Access Compliance Report Public Rights-of-Way (Curb Ramps)

Main Street: RAINBOW_DR Cross Street: DEAN_ST Location: N

ADA ID: RPRK211014152712 Ramp Type: Type 1 - Perpendicular Diagonal Initial Pass/Fail: Fail Overall Compliance: No Severity Score: 16

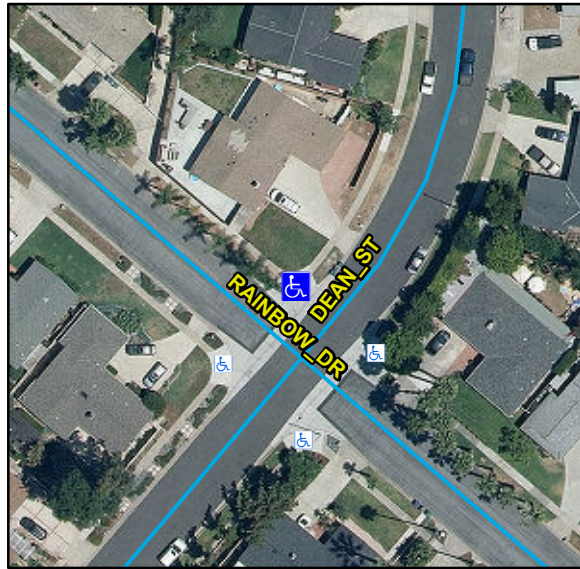
Compliance	Description	Data	Compliance	Description	Data
N/A	Ramp Length (in)	121	N/A	Flare Type LT	
Yes	Ramp Width (in)	48			N/A
No	Ramp Run Slope (%)	8.6	N/A	Flare Slope LT (%)	N/A
Yes	Ramp Cross Slope (%)	1.3	N/A	Flare Traversable LT	N/A
N/A	Landing Present	N/A	N/A	Flare Type RT	
N/A	Landing Length (in)	N/A			N/A
N/A	Landing Width (in)	N/A	N/A	Flare Slope RT (%)	N/A
N/A	Landing Run Slope (%)	N/A	N/A	Flare Traversable RT	N/A
N/A	Landing Cross Slope (%)	N/A	N/A	DWS Provided	N/A
N/A	Landing Movement Obstructed?	N/A	N/A	DWS Contrast	N/A
	Landing Movement Type	N/A	N/A	DWS Length (in)	N/A
N/A	Landing Shared	N/A	N/A	DWS Full Width	N/A
N/A	Clear Space	Yes	N/A	DWS Offset Left (in)	N/A
N/A	Clear Space To Crosswalk (in)	N/A	N/A	DWS Offset Right (in)	N/A
N/A	Marked Crosswalk 1	No	N/A	Marked Crosswalk 2	No
	Crossing 1 Direction	SW		Crossing 2 Direction	SE
	Marked Crosswalk 1 Width (in)	N/A		Marked Crosswalk 2 Width (in)	N/A

Remove & Replace Curb Ramp With Two New Directional Ramps or Equivalent.
